Aeronautical Study No.
2020-WTE-1420-OE
Prior Study No.
2019-WTE-4429-OE

**** MARKING & LIGHTING RECOMMENDATION ****

Structure:	Lighting Study for Wind Turbine A1
Location:	Clear Lake, SD
Latitude:	44-34-49.02N NAD 83
Longitude:	96-35-48.00W
Heights:	1921 feet site elevation (SE) 499 feet above ground level (AGL) 2420 feet above mean sea level (AMSL)

High-Visibility Sleeves.

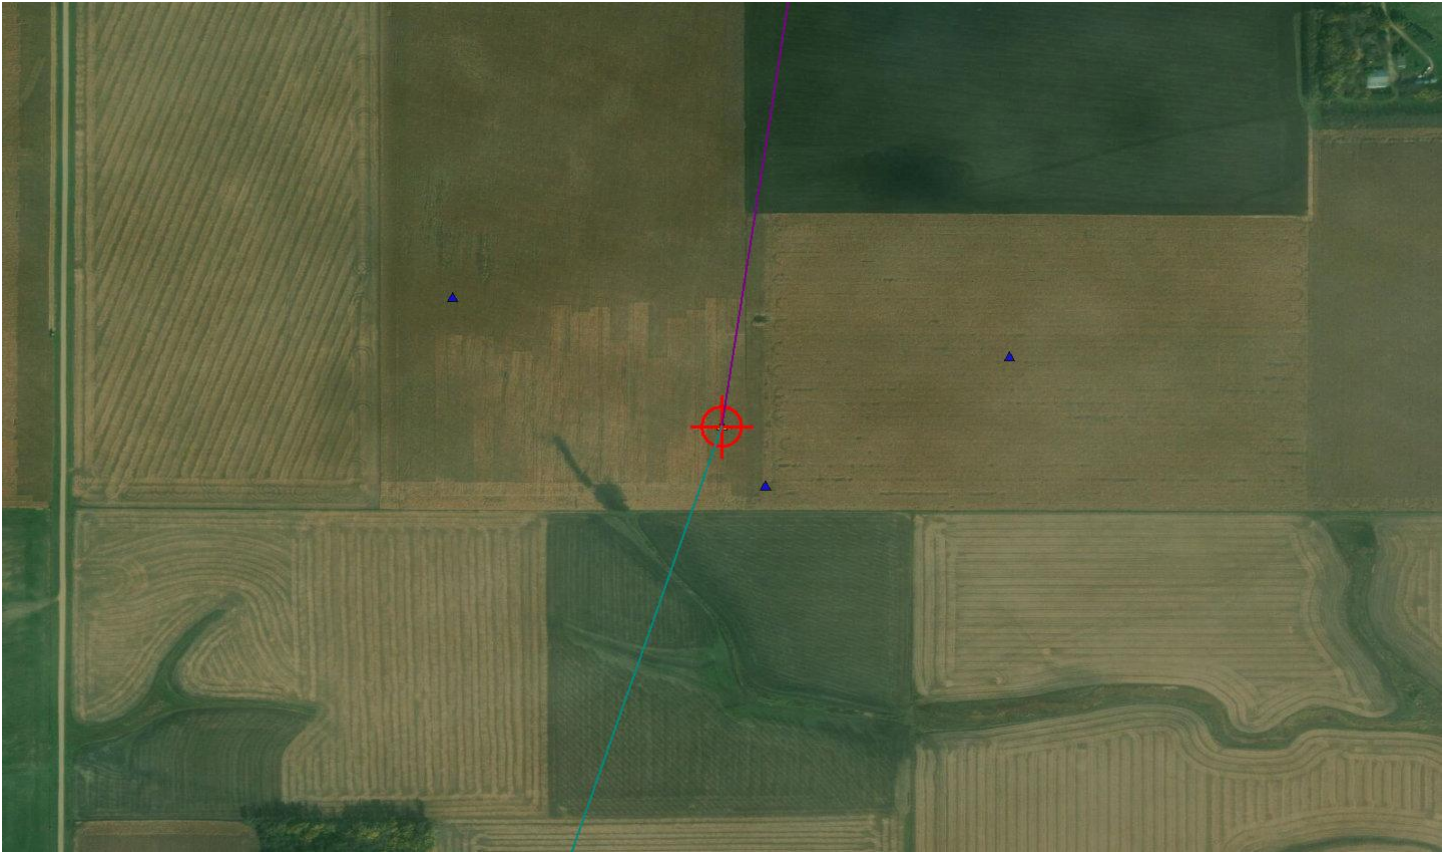
In addition to red obstruction lights, and as a condition of this determination, the structure must be marked in accordance with AC 70/7460-1L, CHG 2, Chapter 2.7:

It is recommended that several high-visibility sleeves be installed on the MET's outer guy wires. One high-visibility sleeve should be installed on each guy wire, as close to the anchor point as possible, but at a height well above the crop or vegetation canopy. A second sleeve should be installed on the same outer guy wires midway between the location of the lower sleeve and the upper attachment point of the guy wire to the MET. The use of sleeves should not impact the placement of spherical marker balls.
